**SUBJECT: Genesis Solar Energy Project (09-AFC-8C)  
Staff Analysis of Proposed Modifications**

# **GENESIS SOLAR ENERGY PROJECT (09-AFC-8C)**

## **Petition to Amend Commission Decision**

**FIGURE 1**  
Genesis Solar Energy Project - Options A & B View 1

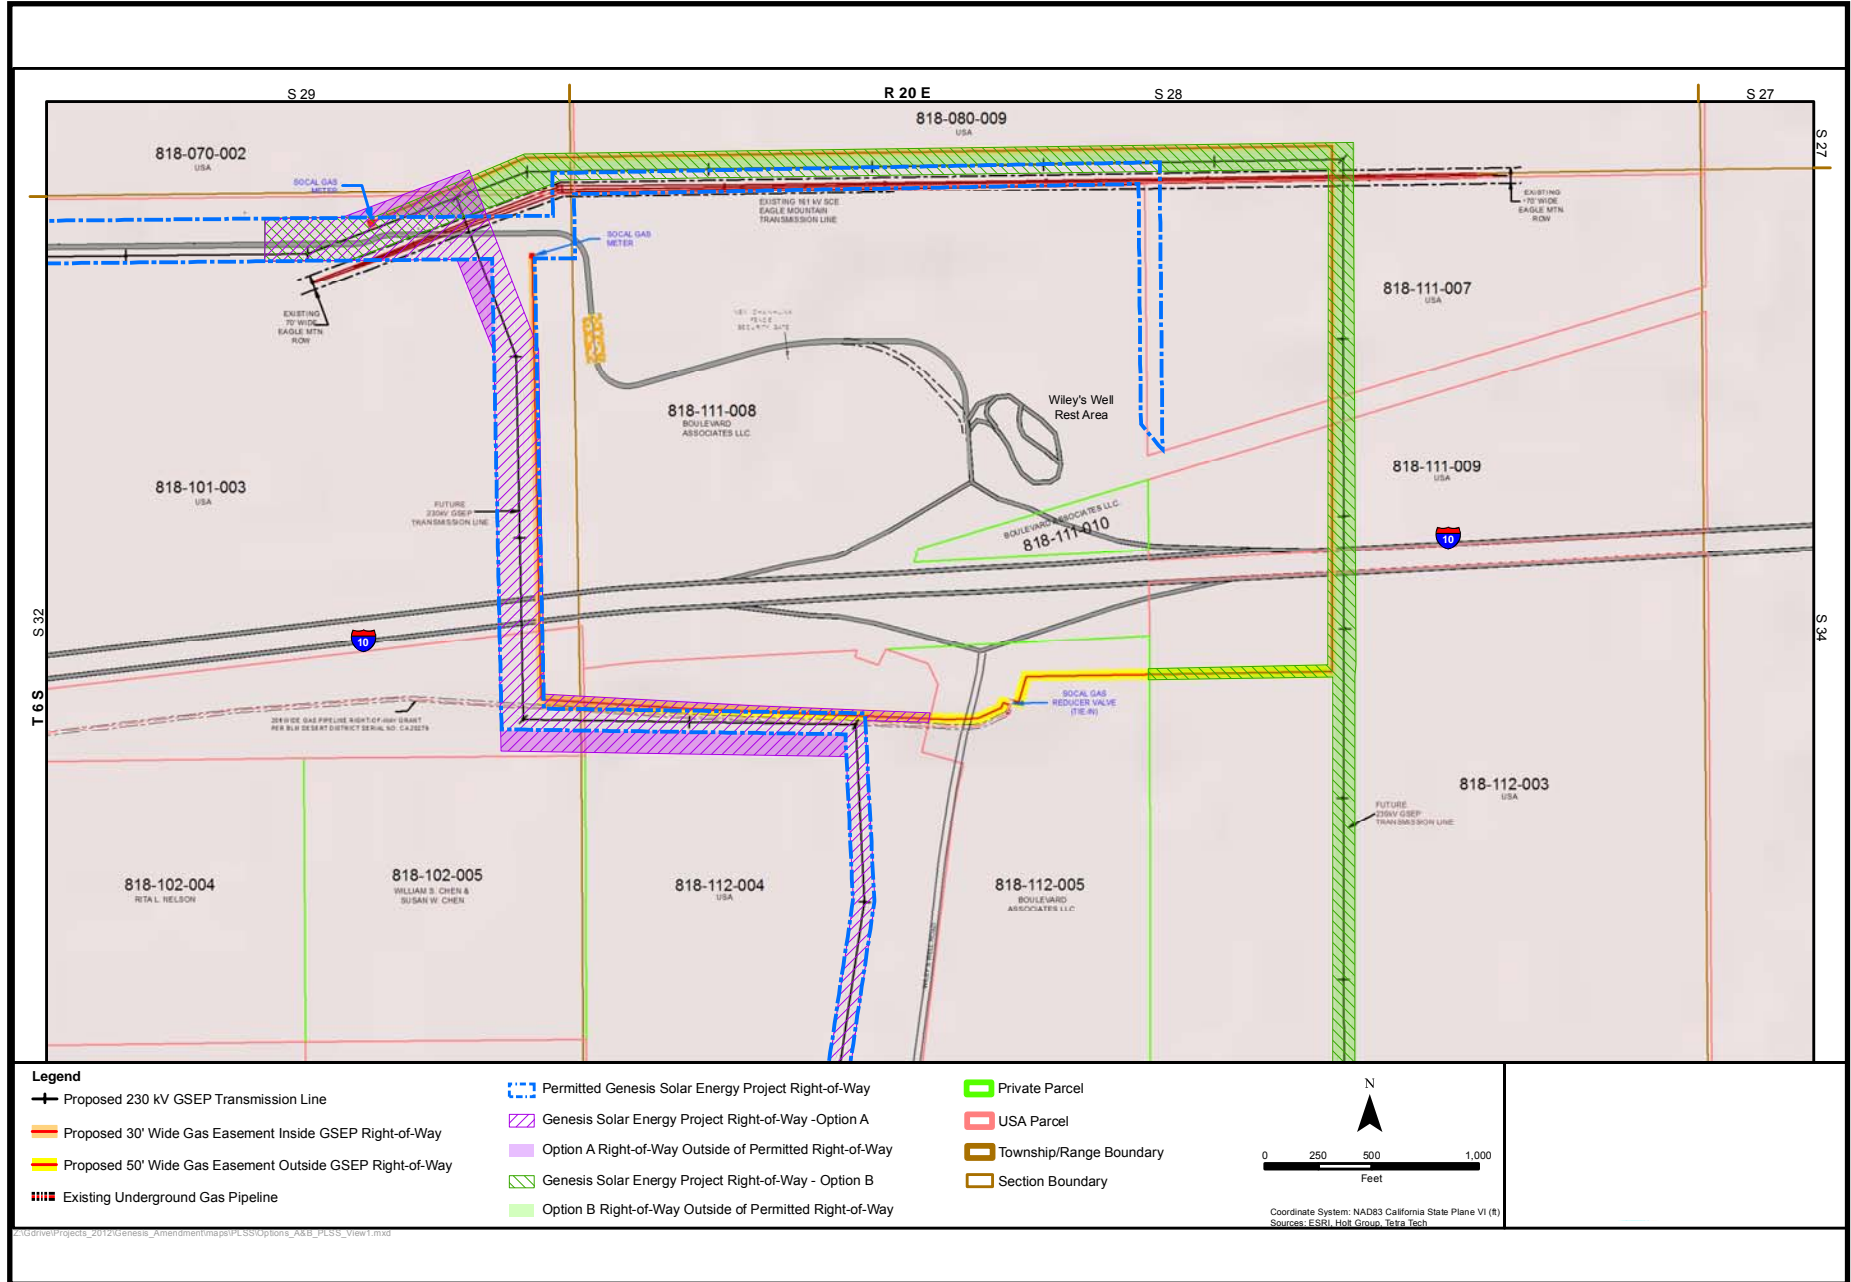
1. Option A and Option B for linear electricity transmission routes. Option A is a modified transmission route predominately the same as the route originally approved by the Commission. Option A contains a slight modification to the proposed right-of-way at the point where the proposed 230 kV GSEP transmission line passes under the existing Eagle Mountain transmission line, and another slight modification to the proposed right-of-way in the section of the

proposed GSEP transmission line that parallels (east to west) the existing gas pipeline right-of-way that is south of I-10. Option B differs from Option A in that the proposed 230kV GSEP transmission line jogs slightly north and to the east as it leaves the project site, running behind the Wiley's Well rest area for approximately one mile instead of turning south before the rest area. East of the rest area, the transmission line in Option B turns south in a straight line to the point at which the transmission line is co-located with the Blythe Energy Transmission Line (BETL). The points at which both Option A and Option B begin co-location with the BETL are very nearly the same, and both proceed easterly to the CRSS in an identical fashion. The applicant has requested review and approval of both Option A and Option B.

- 1) Modifications to the Gen-tie linear route (w/ Options A and B) (see Figures 1 and 2)
- 2) Modifications to the natural gas pipeline linear route due to a new point of interconnect with the Southern California Gas Company (SoCalGas) natural gas supply (w/ Options A and B) (see Figure 1)
- 3) Implementation of the Large Generator Interconnect Agreement (LGIA) and the resulting redesign/reconfiguration of the connecting substation that will be required to deliver power to the CRSS (see Figure 3)
- 4) Changes to Air Quality conditions related to changes in the permit issued by the Mojave Desert Air Quality Management District (MDAQMD)
